RE: 116 W Oak Street – Front (South) Façade Exterior Alterations

On February 23, 2024, staff received revised plans from the applicant that showed the following changes (see Exhibit C):

Exhibit A

Exhibit C – AMENDED PLANS

Figure 1: New Proposed Entryway

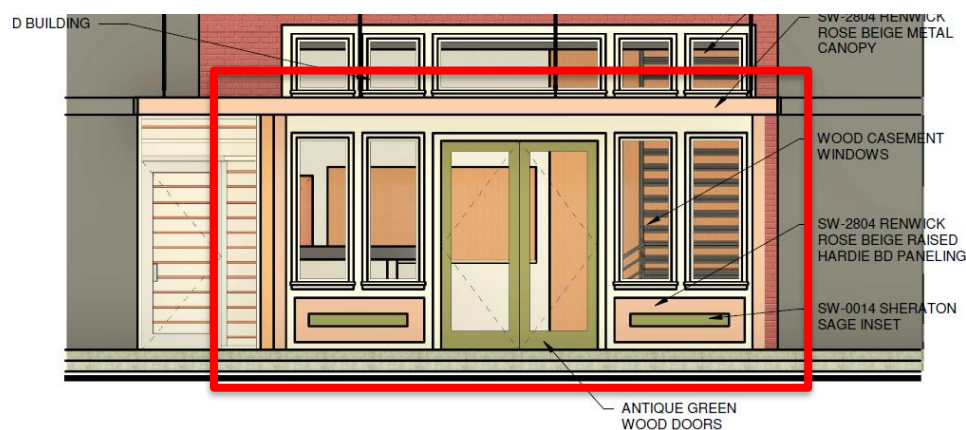
- Removal of the columns; and
- Removal of the recessed entry

Per staff's review of the material provided, and per Sections 4.10.7C and 4.10.7D above, the amendment to the plans has been administratively reviewed and approved by the Historic Preservation Officer.

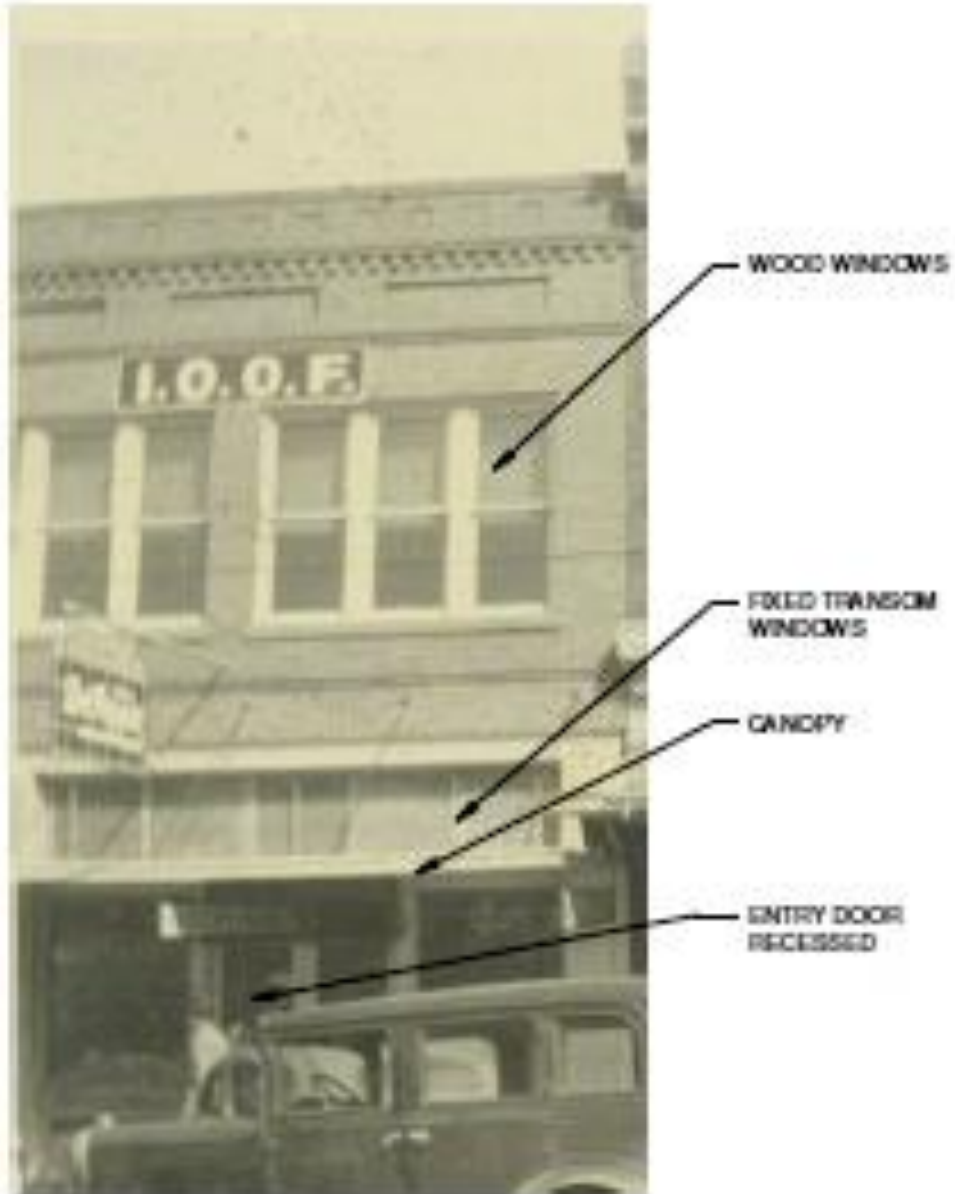
Brick / Paint: The goal is to remove the exterior paint revealing the original brick, however if the brick proves to deteriorate due to paint removal, we will paint the brick with a historically appropriate paint color from the Sherwin Williams Historic Color Palate as directed by Cameron. New brick columns street level will be painted to match the style in the 1938 photo.

Awning: The existing large awning is not structurally sound and is rusted, nor is it consistent with any of the historical photos. Since the requirement is to match a documented (with photo) historical style prior to 50 years prior to current date, keeping the existing awning would not be possible even if it were structurally sound. The plan is to install a new steel flat awning consistent with the 1938 photo which will reveal the transom windows.

Transom Windows: The transom windows were hidden when the large awning & sign were installed by McBride's, but the openings are still there. New windows will be installed in concert with the 1938 photo.

Street Level: Because the desired use is restaurant, we want to allow for a covered patio inset behind the front of the building (property line). The businesses on the square benefit from foot traffic and a vibrant active downtown, as has been proven over the last 10 years as more restaurants have located on the square. As you will see in the architects conceptual drawings, he has designed a front façade consistent with the vertical elements in the 1938 photo that captures the look and feel from 1938 while allowing the storefront entry to be inset about 20 feet. This will allow for patio dining while not obstructing the sidewalk (which can be a challenge in other areas of the square where restaurants place tables on the public property).

The existing old style inset entry with display windows on each side will be completely removed, allowing for usable patron dining space while achieving the 1938 look.
